SERVICE BULLETIN

No. 0014

SUBJECT: Fuel Tank Venting System.

PEGASUS XL-R.
PEGASUS FLASH.
PEGASUS FLASH 2.

FIG. 1.

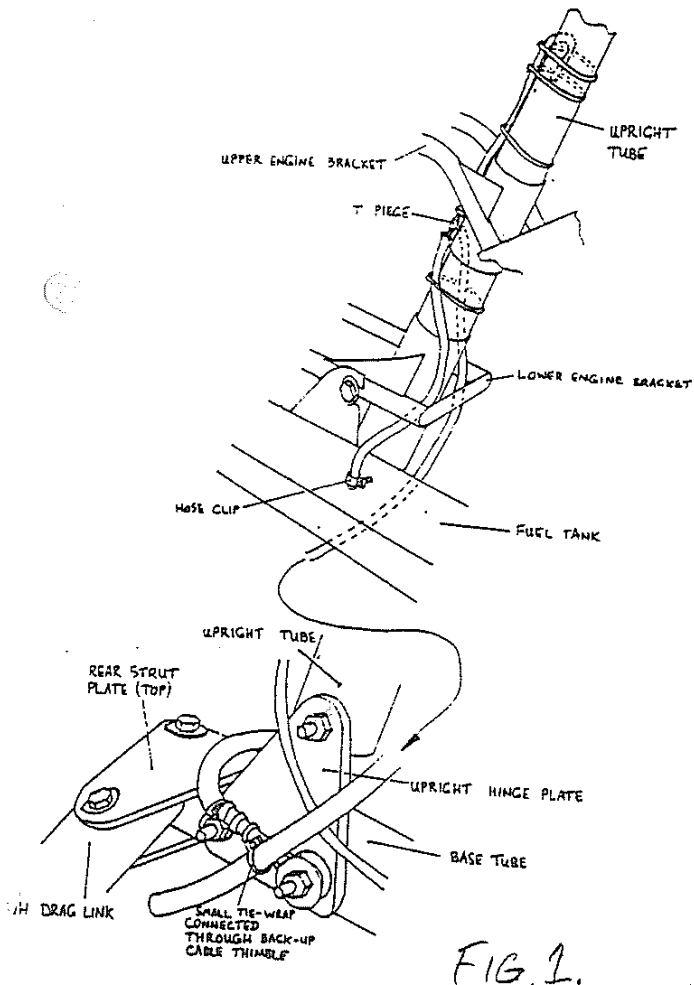
A field report has been received of an aircraft with its fuel tank 'brim full' and a further 25 litres of fuel in the rear passenger seat, catching fire whilst taxiing to its intended take-off point. The extent of the damage sustained was considerable, and will probably preclude any chance of pin pointing the actual cause. However, the aircraft was fitted with a non-standard battery and rectifier placed immediately above the fuel tank and below the fuel tank vent. Apart from the obvious questions raised about the fitting of non-standard components and the carrying of excess fuel, it is felt that the fuel tank venting system could be modified to cover situations where the tanks have been over filled and the aircraft is being taxied over rough ground. Accordingly, affected aircraft are to be modified as outlined in this service bulletin.

- i. Remove the plastic Tie-Wraps attaching the vent pipe to the monopole.
- ii. Cut the vent pipe in two 350mm down from the top of the straightened vent pipe 'U' bend.
- iii. Route the lower part of the vent pipe as outlined in Fig 1.
- iv. Connect the remainder of the system as outlined in Fig. 1.
- v. Arrange the 'U' bend as outlined in Fig.2.

Note. When re-fitting the vent tube, ensure that the shoulder restraint webbing is not trapped between the vent pipe and the monopole.
